**Re: Waste Licence Application W0250-01 - Article 14 Response**

**Re: Waste Licence Application W0250/01 - Kerry Central Recycling Facility Ltd.  
- Response to Article 14 Notice**

## Waste Licence Application No. W0250-01 Article 14 Notice - Response

Client	Kerry Central Recycling Facility Ltd.					
Project Title	Waste Licence Application no W0250-01					
Document Title	Article 14 Notice - Response					
Document No.	MGE0109RP0016					
This Document Comprises	DCS	TOC	Text	List of Tables	List of Figures	No. of Appendices
	1	1	80	1	1	5

Figure 6.1 2005 Wind Rose from nearest meteorological station (Valencia Observatory)

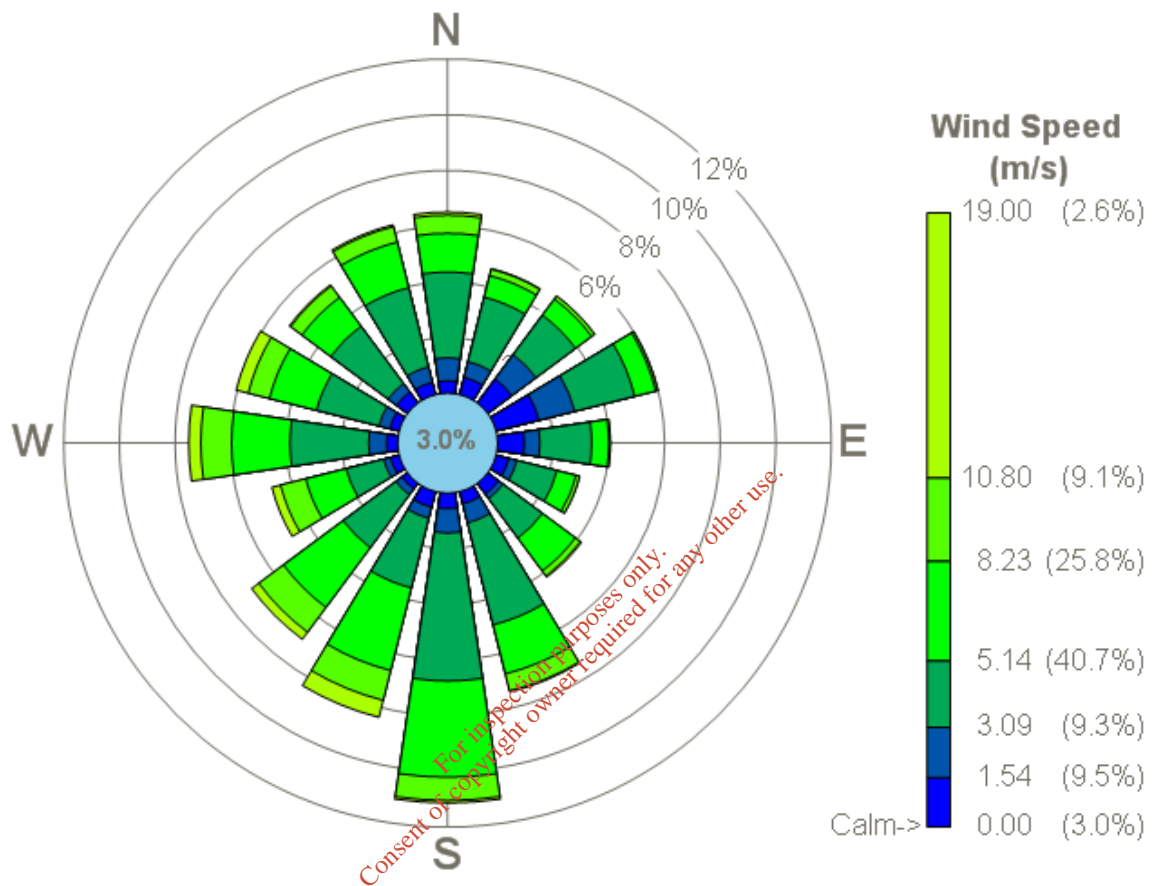
### RESPONSE

Meteorological data for Valentia was used to determine the local weather conditions for the site. The Met data wind rose for Valentia was consulted (this is shown attached - **Figure 6.1**). Rainfall data for Valentia was also obtained and demonstrated a 30 year mean monthly rainfall of 1430 mm. This was compared to rainfall data for Dublin Airport which is substantially less at 732mm. A higher than average rainfall level demonstrated for the region would lead to decreased levels of suspended dust.

FIGURE 12: SECTION OF A PERCOLATION TRENCH

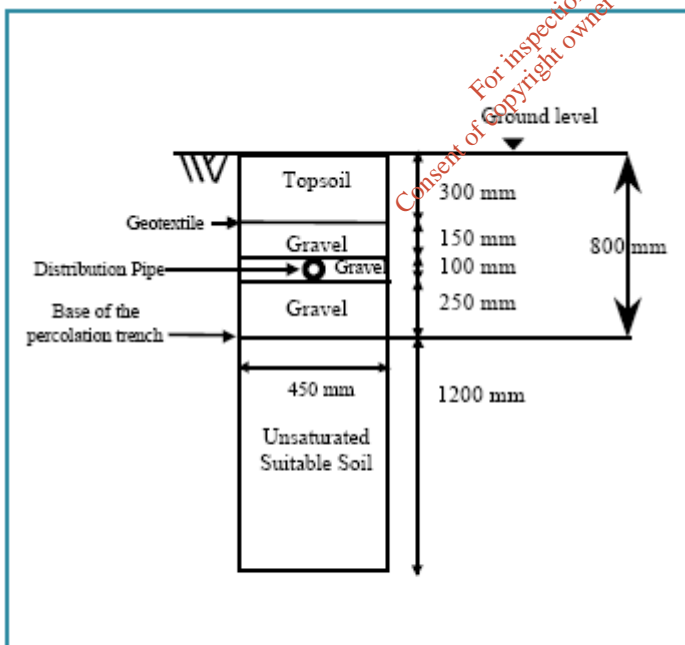
**Sanitary Effluent:** Clarify what is the depth of the polishing filter to be used in the sanitary effluent treatment system and justify that it is sufficient to prevent the contamination of groundwater.

A site suitability assessment was carried out in May 2008 to assess the appropriate wastewater treatment system for the site. This consisted of a visual assessment, trial hole and percolation tests. The Site Characterisation Form is included in Appendix A of the Drainage Calculation Report (June 2009). The assessment determined that there is adequate percolation and treatment of wastewater can be carried out by utilizing a raised bed soil filter.

The base of the soil filter will be at a height of 1.2m above the highest water mark. This is in accordance with the minimum depth requirements of the EPA Wastewater Treatment Manual.

Project	<b>Kerry Central Recycling Facility</b>	Figure	
Title	<b>Nearest Residential Dwellings to Site Boundary</b>		
RPS Consulting Engineers Lyrr Building DA Business & Technology Park Merivee Galway		Ph: 091-534100 Fax: 091-534199 E: ireland@rpsgroup.com W: www.rpsgroup.com/ireland

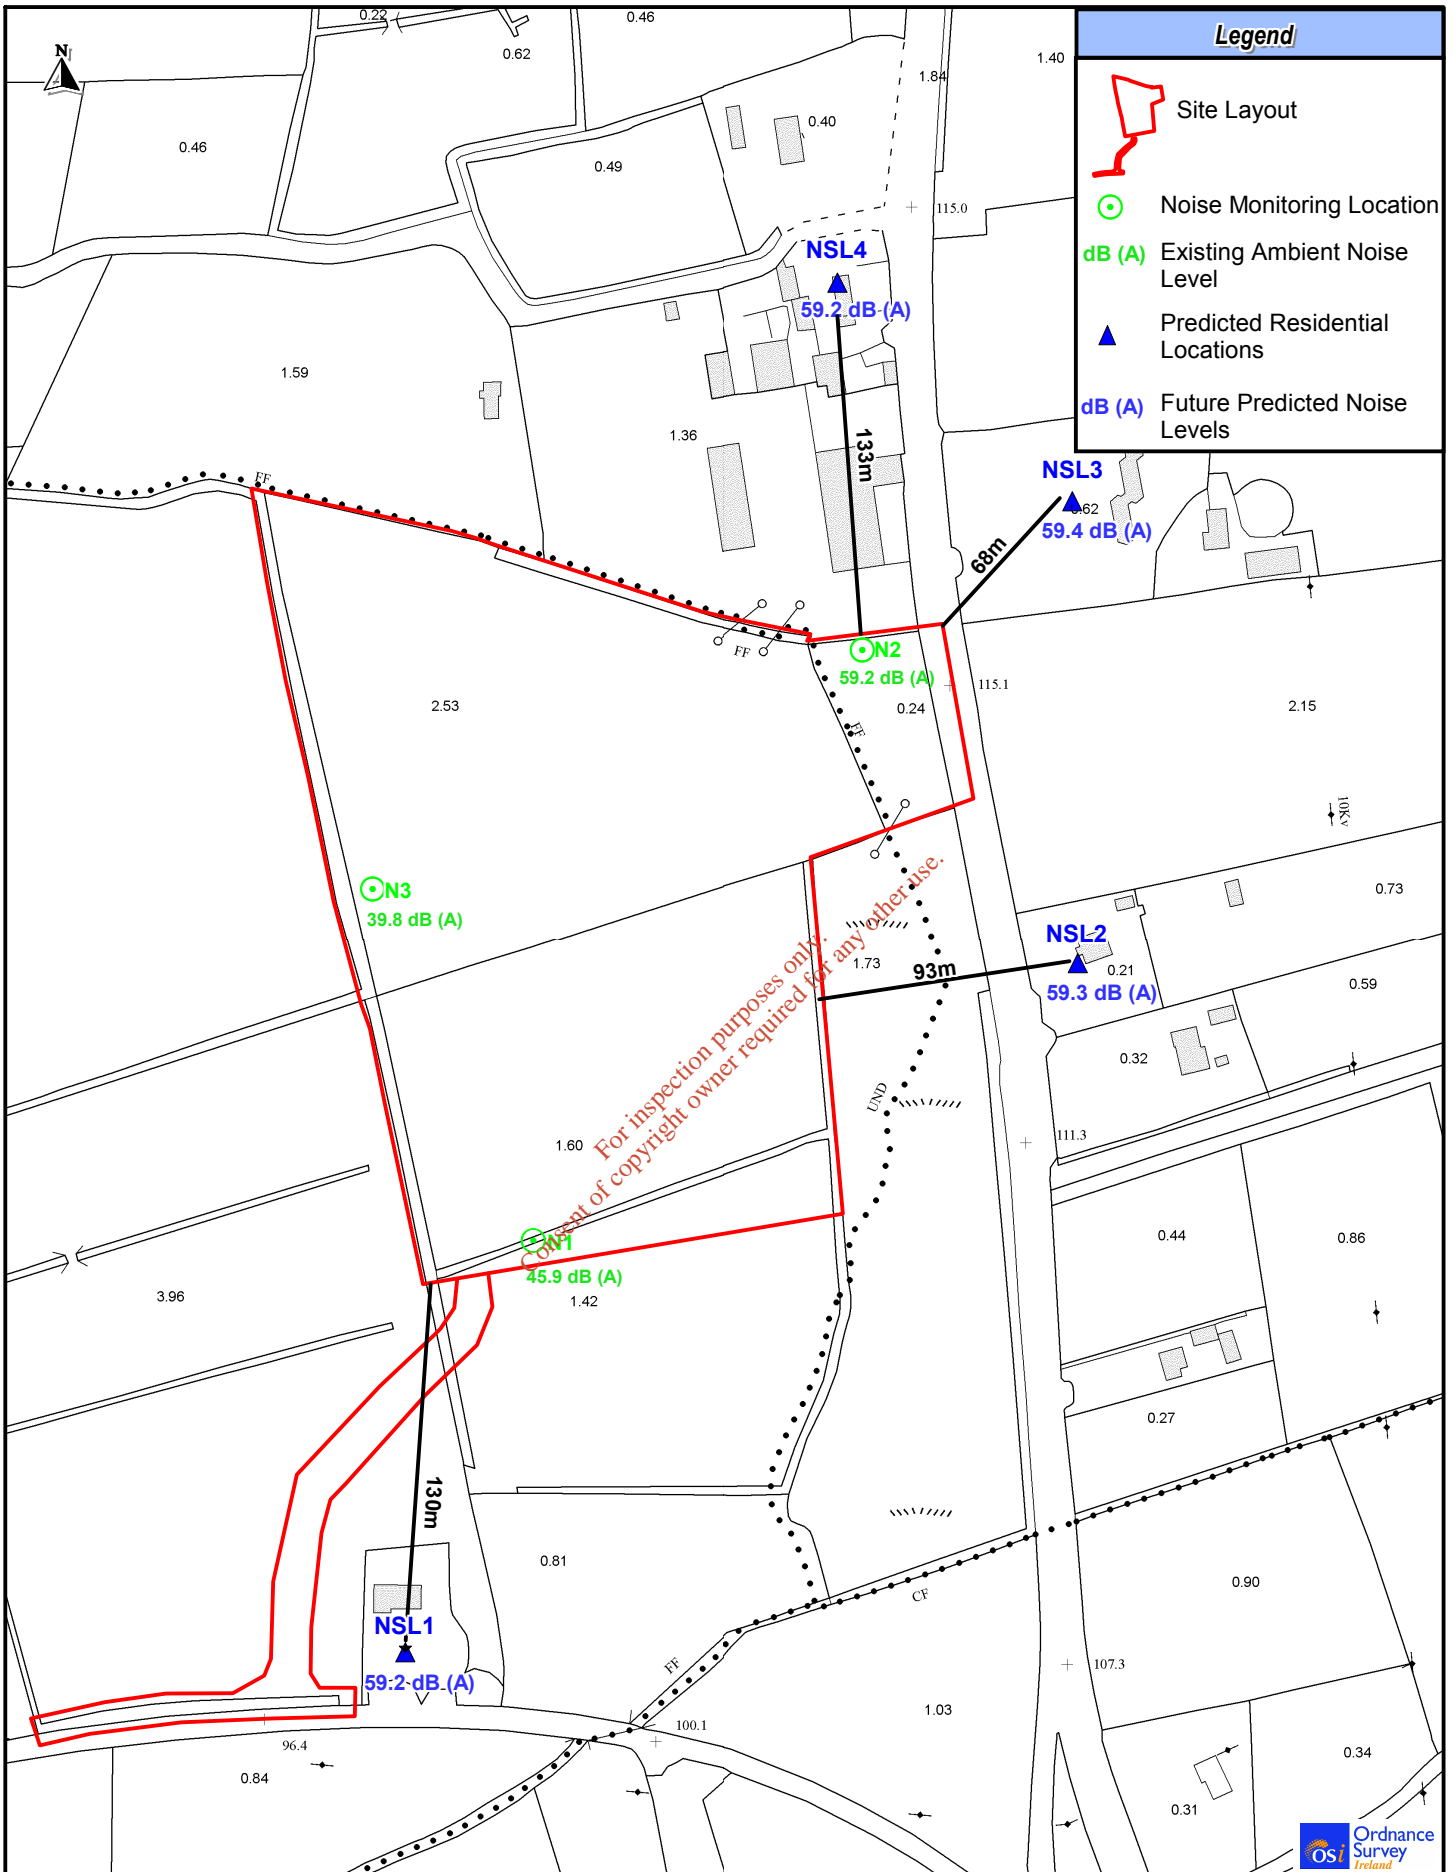
- (ii) **Provide a full copy of the report of the noise model and amend as necessary to include a map indicating predicted noise levels at the noise sensitive locations.**

Drawing **MI00013F01** shows the noise monitoring locations and the NSL's. Also detailed on this drawing are the predicted contribution of noise from the proposed facility at the NSL's.

Noise levels were also predicted at four NSL’s. This prediction took account of the contribution that the proposed facility will have to future noise levels on its own and in

combination with the existing ambient noise levels recorded. The location of these NSL's is shown on drawing **MI00013F01** and presented in **Table 11.3**.

However the nearest noise sensitive location (NSL) is NSL3 as shown in Drawing No. **MI00013F01**. For clarity, predictions have been made for all noise sensitive locations NSL1 to NSL4 as shown in Table 11.7 and illustrated in Drawing No. **MI00013F01**.
